CONSTRUCTION PLANS
FOR
**CARRIAGE MEADOW SOUTH AT
LORSON RANCH FILING NO. 2**

**EARLY GRADING PLANS
AND DETAILED GRADING PLANS**

PUDSP-19-005

DATE: DECEMBER, 2018
 PROJECT NO. 100.046
 SHEET NUMBER C4.9
 TOTAL SHEETS: 14

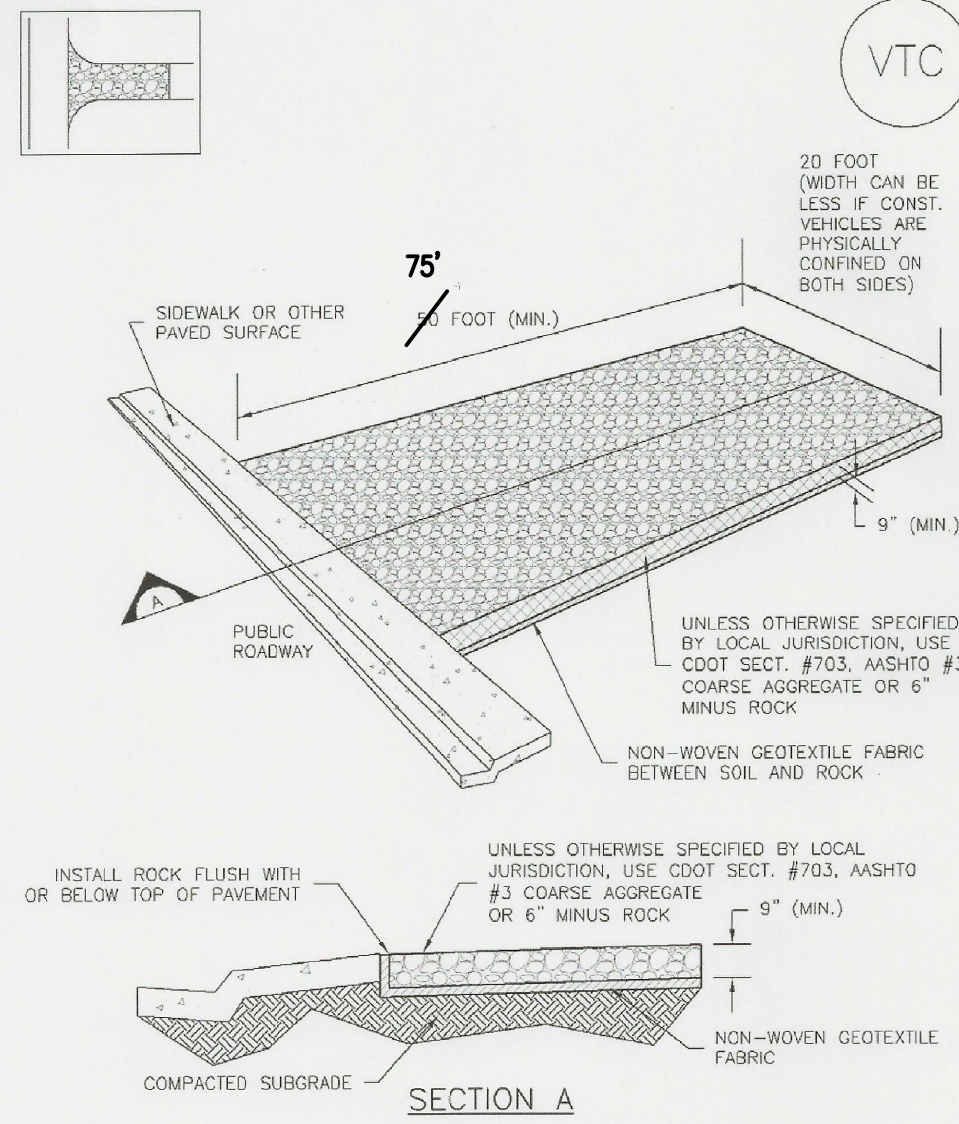
Call out another temporary sediment basin for this area/basin also.

Call out ditch checks or other erosion measures for Rubicon Trail.

DATE: DECEMBER, 2018
PROJECT NO. 100.046
SHEET NUMBER C4.10
TOTAL SHEETS: 14

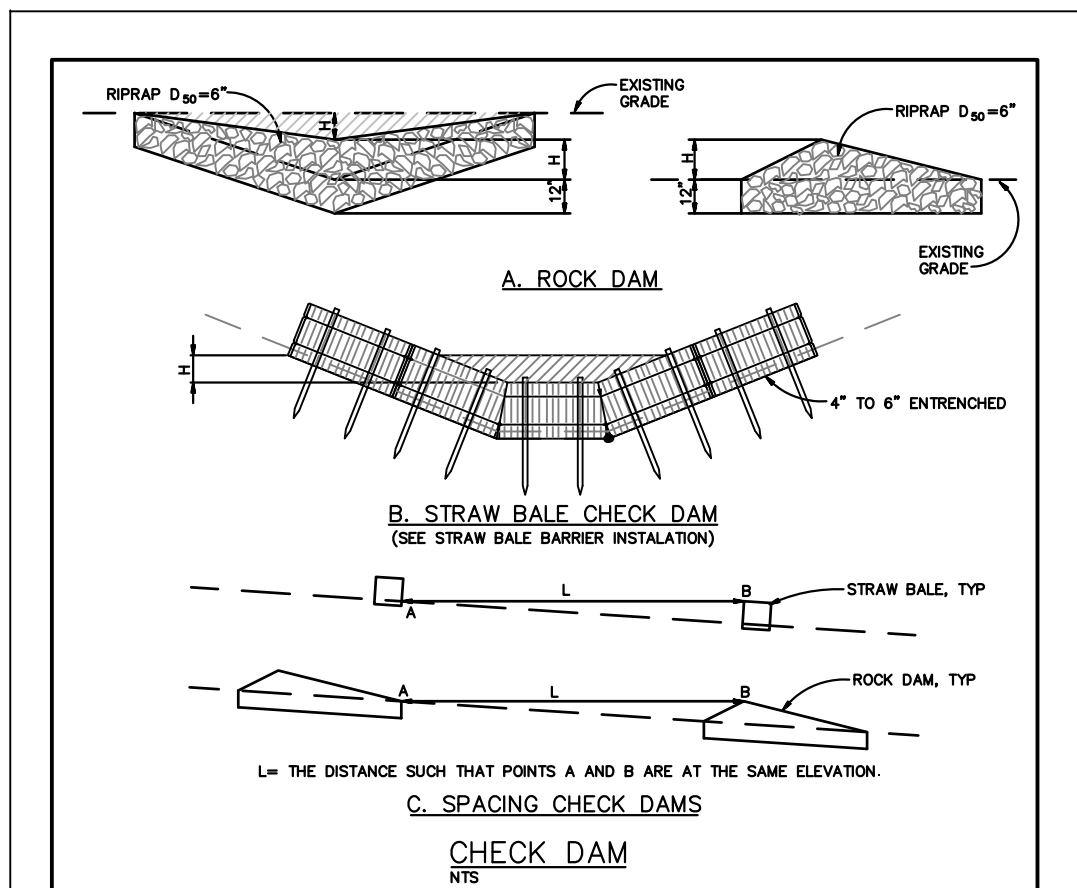
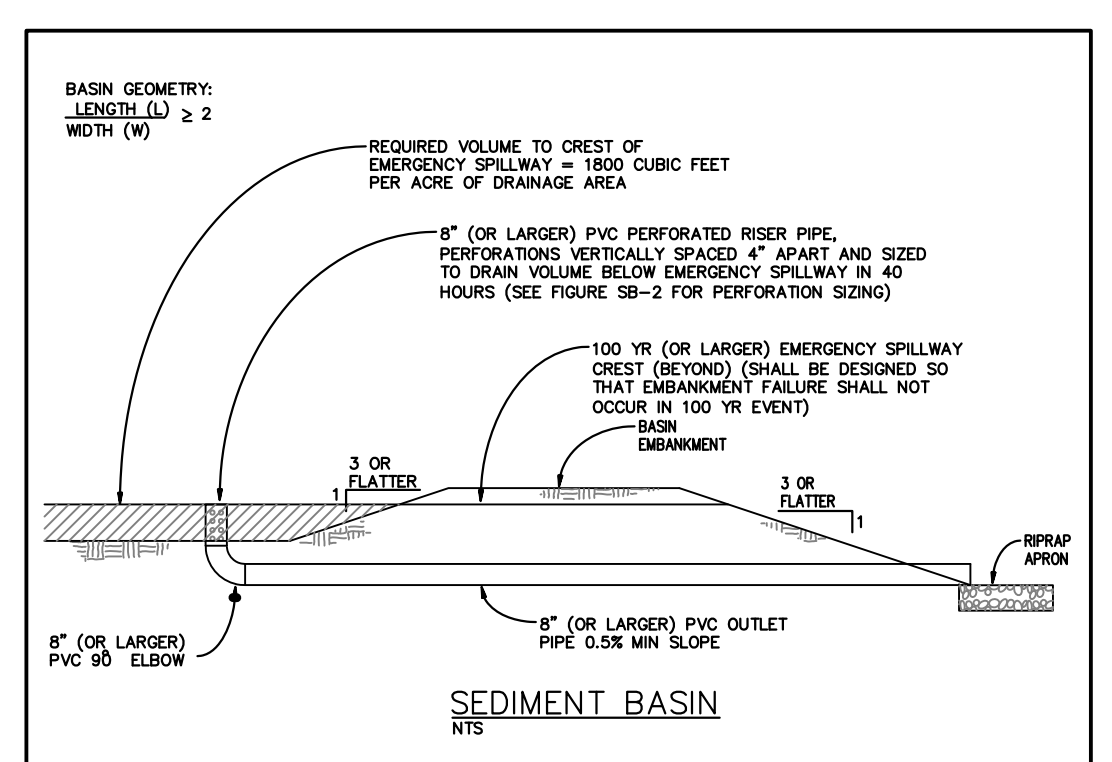
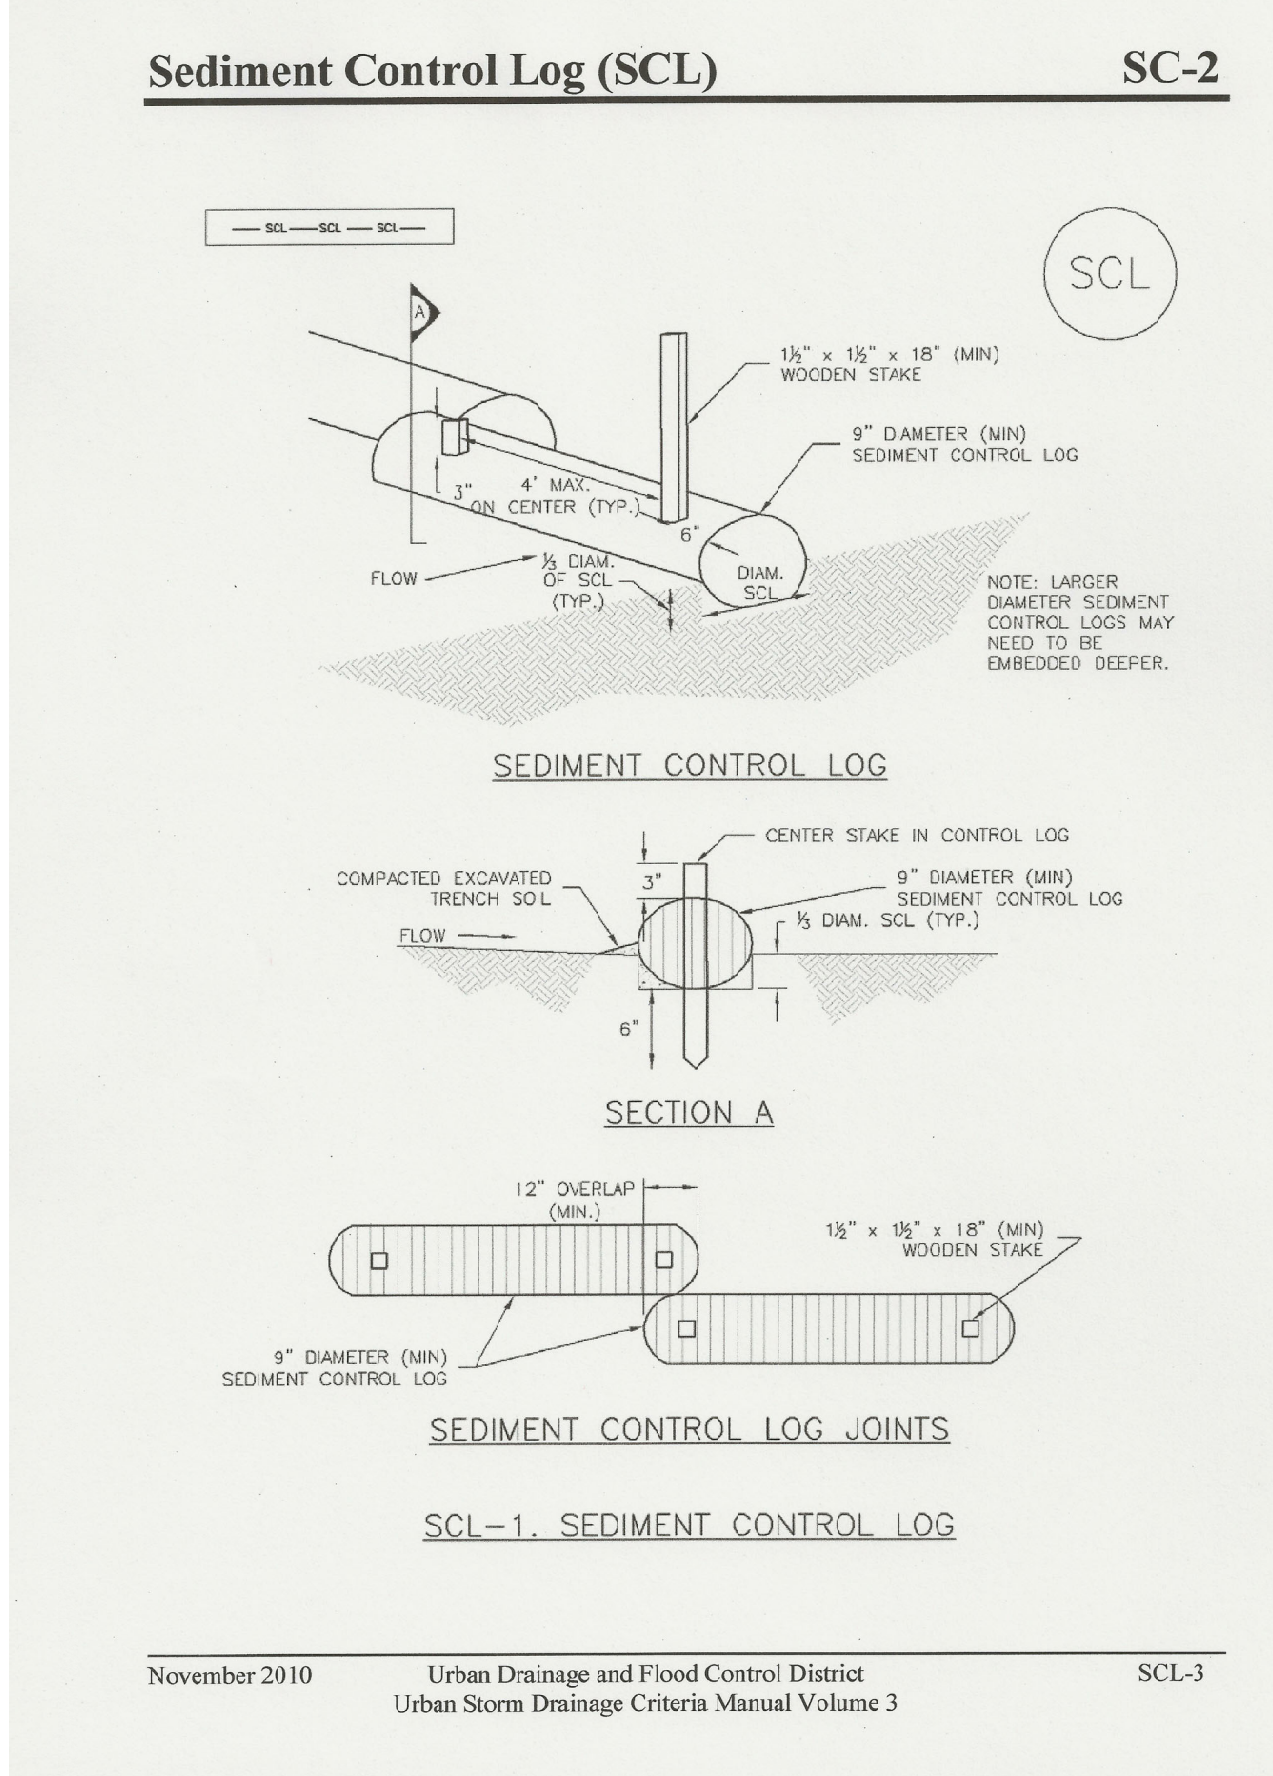
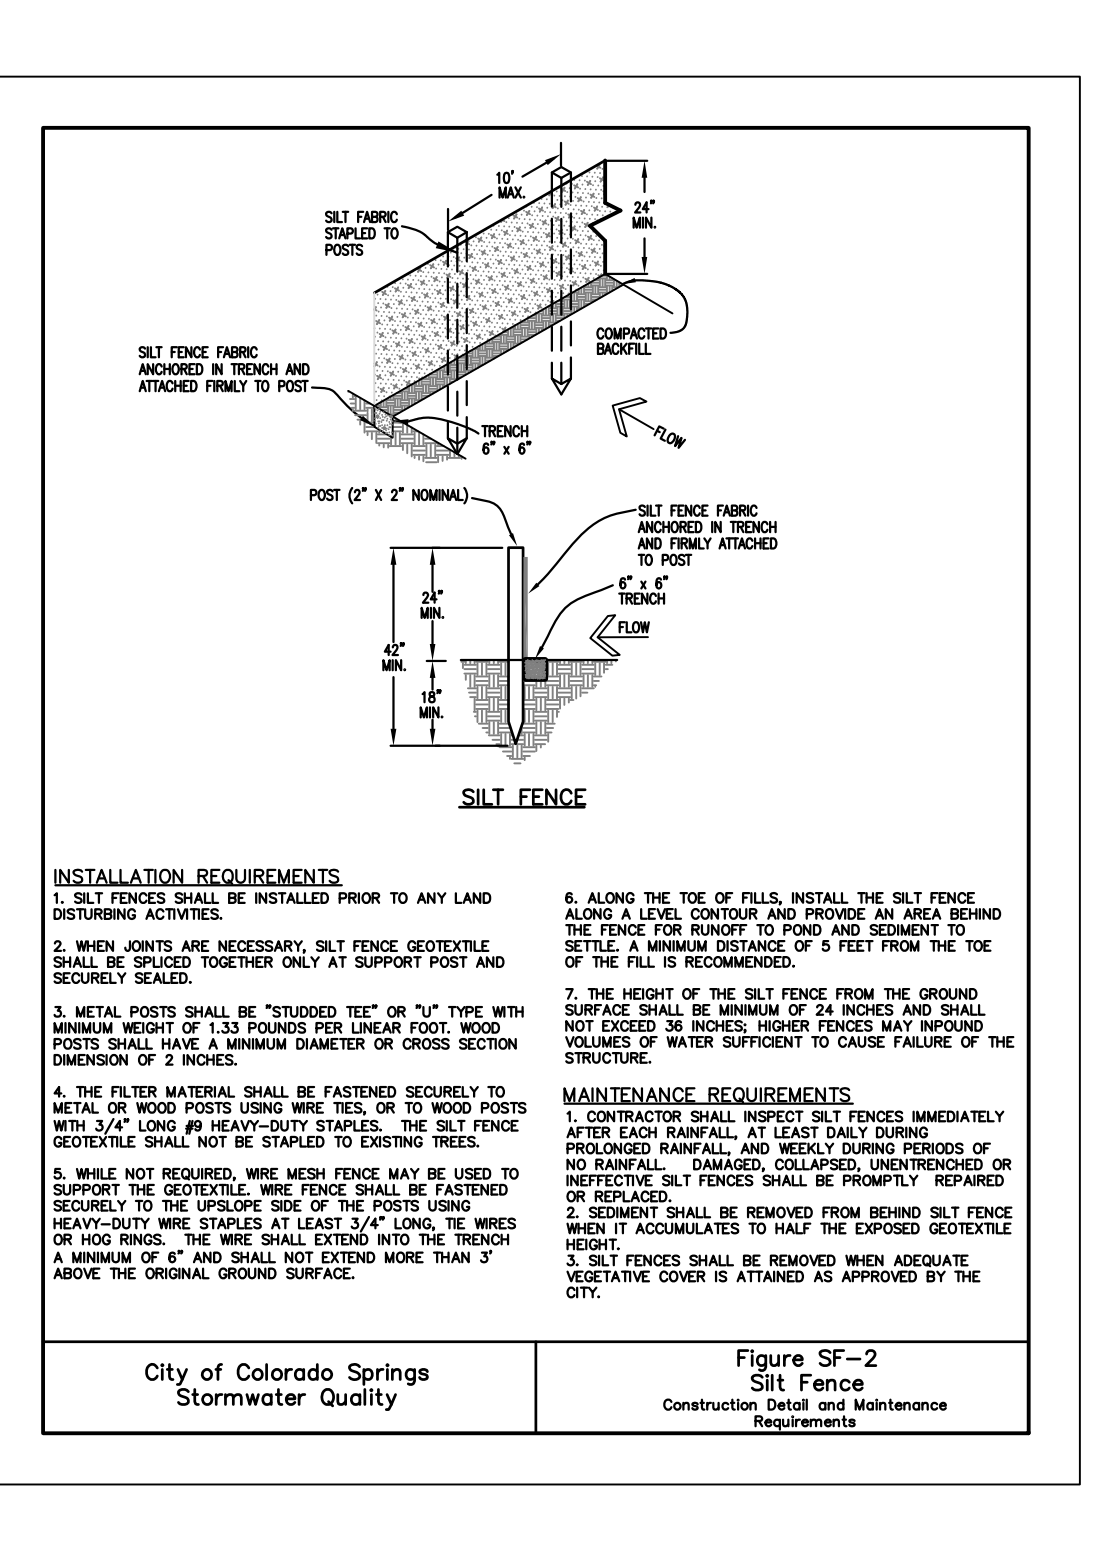
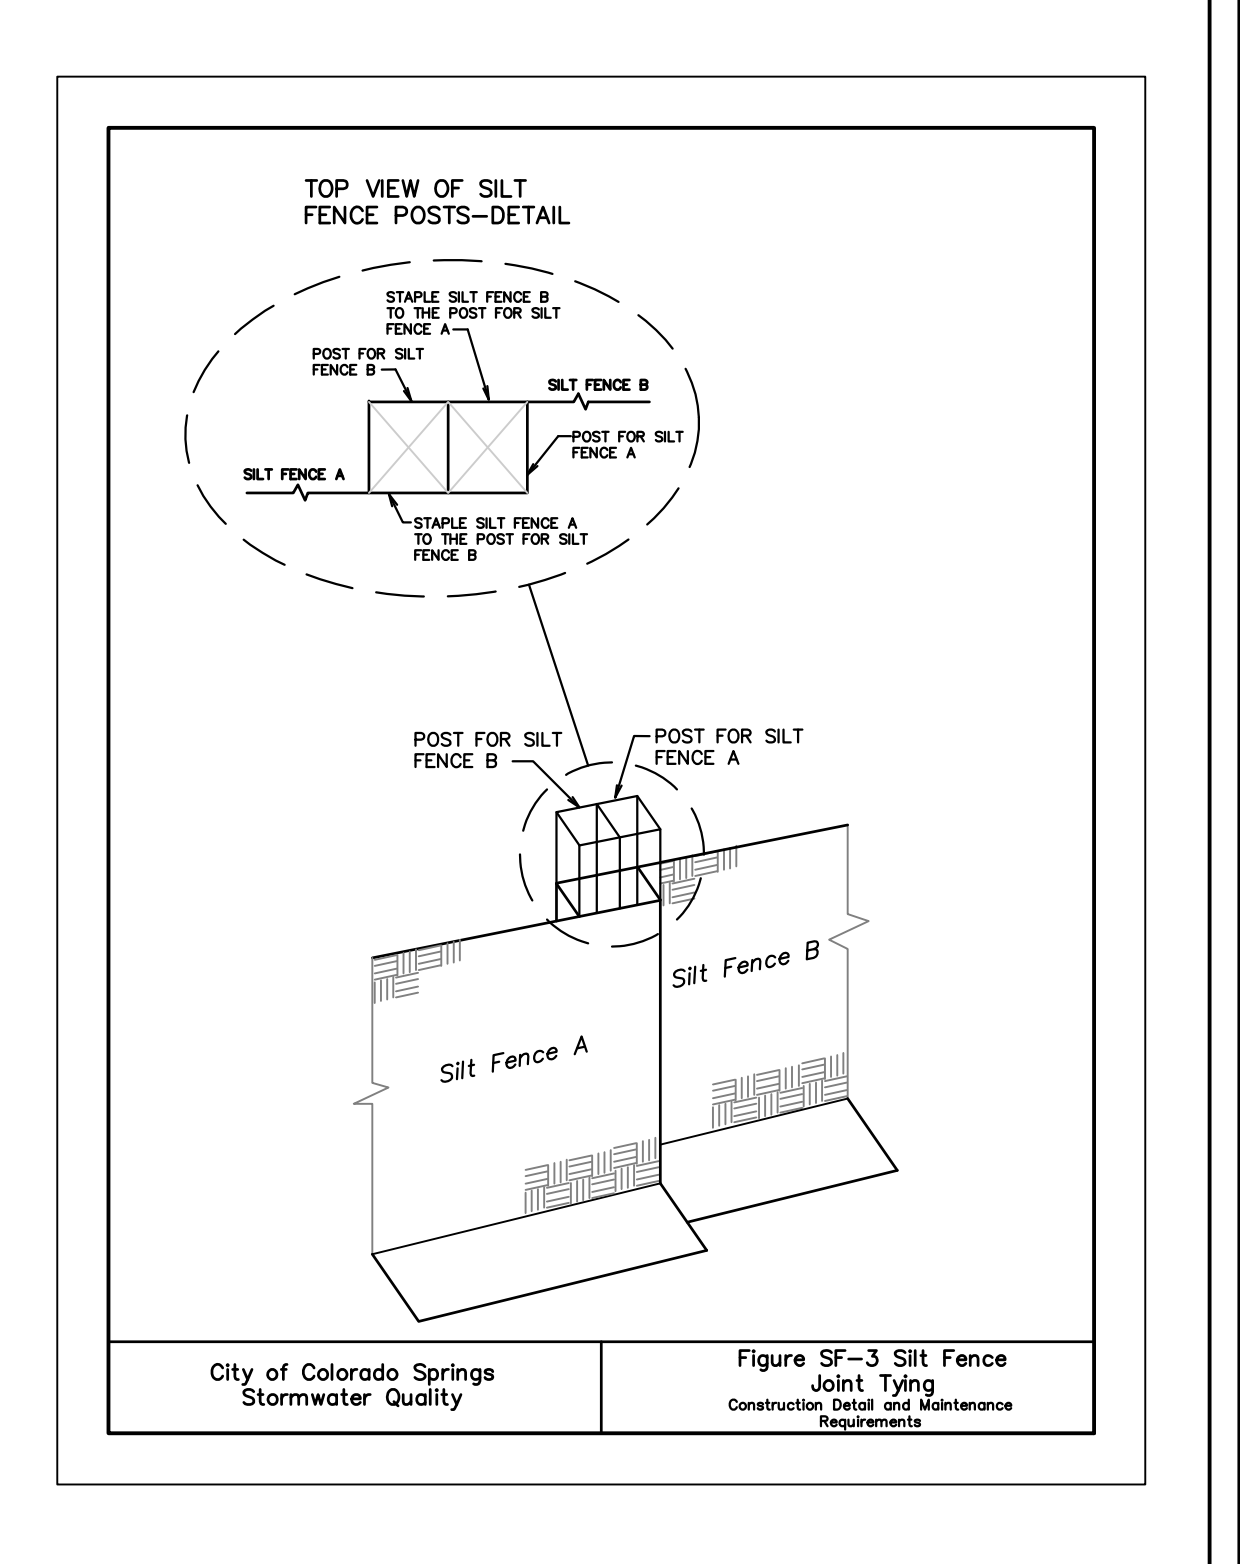
Please expand the size of these 10 details so they cover evenly these two plan sheets. We would like to be able to have the printed out and read on an 11 X 17 paper.
